PLANNING, ZONING, & BUILDING DEPARTMENT
PZ&B Combination Memorandum: Architectural Commission (ARCOM) and Town Council

SUBJECT: ARC-23-036 (ZON-23-050) 243 SEASPRAY AVE (COMBO)

MEETING: APRIL 26, 2023

ARC-23-043 (ZON-23-042) 259 OLEANDER AVE (COMBO). The applicant, 259 Oleander LLC (Uriel Rubinov, Manager), has filed an application requesting Architectural Commission review and approval for demolition of an existing multifamily structure and construction of a new single-family residence requiring variances from lot yard and area requirements in the R-C zoning district, including setbacks and lot coverage. This is a combination project that shall be reviewed by the Town Council as it relates to zoning relief/approvals.

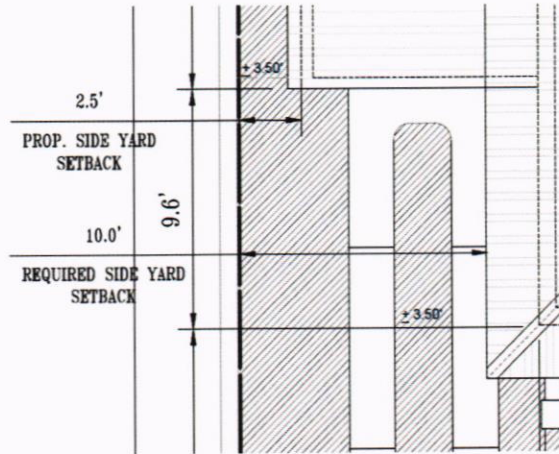
- **VARIANCE 4: Sec. 134-948(5)a.:** A variance request to permit a south front yard setback of 12 ft in lieu of the 25 ft front yard setback required.

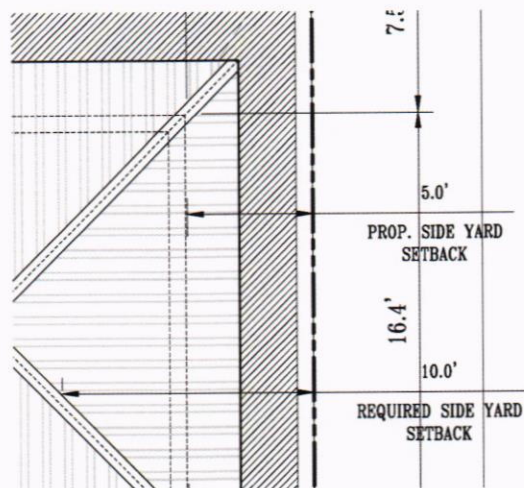
- VARIANCE 5: Sec. 134-948(6)a.: A variance request to permit a west side yard setback of 2.5 ft in lieu of the 10 ft side yard setback required.

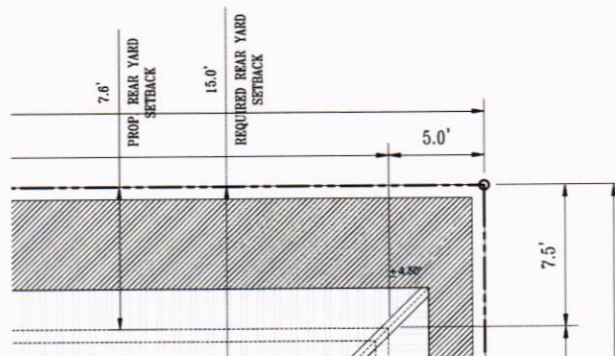
- VARIANCE 6: Sec. 134-948(6)a.: A variance request to permit an east side yard setback of 5 ft in lieu of the 10 ft side yard setback required.

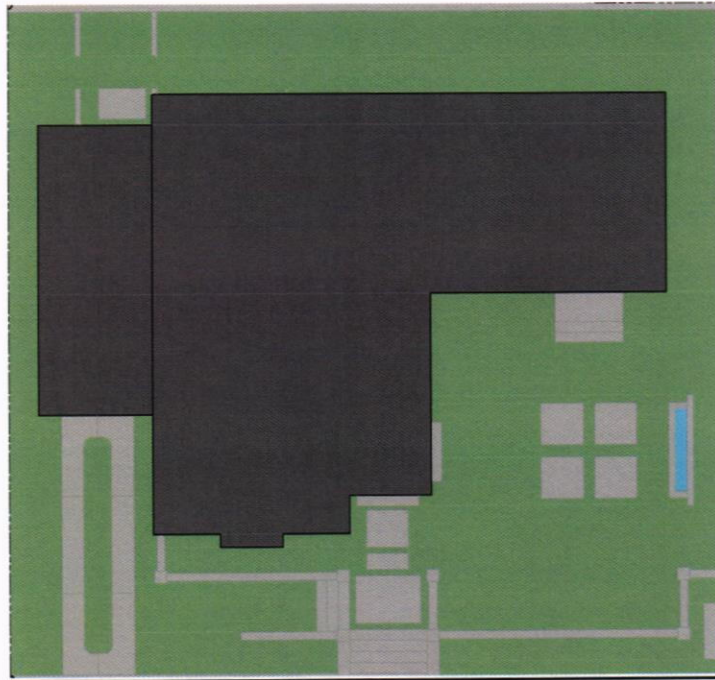
- VARIANCE 7: Sec. 134-948(7)a.: A variance request to permit a north rear yard setback of 7.5' in lieu of the 15' rear yard setback required.
